UNITED STATES PATENT AND TRADEMARK OFFICE

APPLICATION NO.	F	ILING DATE	FIRST NAMED INVENTOR	ATTORNEY DOCKET NO.	CONFIRMATION NO
10/774,556		02/09/2004	James Finn	006163.00004	8975
22908	7590	06/19/2006		EXAMINER	
BANNER &			KLEIN, GABRIEL J		
SUITE 3000		EK DKIVE	ART UNIT	PAPER NUMBER	
CHICAGO,	IL 6060	6	3641

DETAILED ACTION

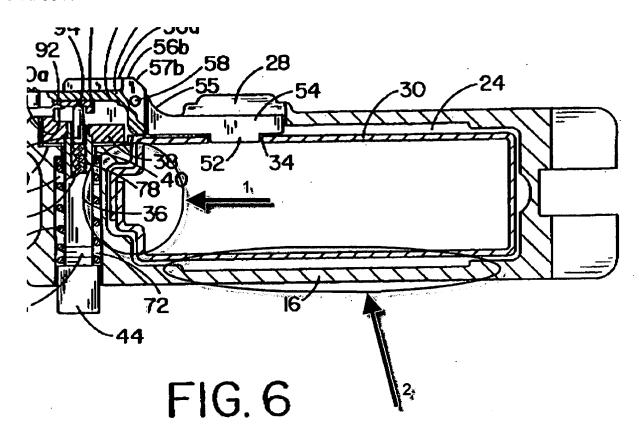
(arrow 2 of the clarified figure below points to a circle encompassing another slot); and

In reference to claim 22, Garret discloses that the slot is positioned on an opposite side of the receiver well compared to the magazine catch (figure 6; see clarified figure 6 below, contents of circle indicated by arrow 2)

Applicant's arguments filed April 18, 2006 have been fully considered but they are not persuasive. Applicant argues that the locking feature as disclosed by Garret is in the same basic location as the retaining feature. However, it is apparent that applicant

has misunderstood the details of the non-final rejection, in particular the location of the slot in the receiver well as disclosed by Garret. Below is a copy of figure 6 from the Garret disclosure with circles and arrows (1 and 2) added for purposes of clarification. In the original rejection it was stated that Garret discloses a slot in the receiver well, wherein the slot is configured to receive a tab on the tabbed magazine when the tabbed magazine is inserted into the receiver well (figures 1, 2, and 6-8, in figures 6-8 the tab of the magazine and the corresponding slot are shown at the leftmost side of the magazine, element 30). Said tab and said slot are clearly shown in the location mentioned above and are clarified by the figure below (arrow 1 points to the circle encompassing said tab and slot). Therefore, it is clearly shown that the locking feature is not in the same basic location as the retaining feature. Further, it is clearly shown that the receiver of Garret is configured to receive a tabbed magazine as evidenced by the figure below. It should be appreciated that the above portion of the rejection has only been altered slightly to account for the amendment made to claim 22 which added the limitation that the slot is positioned on an opposite side of the receiver well compared to the magazine catch. It should be appreciated that Garret discloses multiple slots in the receiver well capable of receiving tabs on the tabbed magazine.
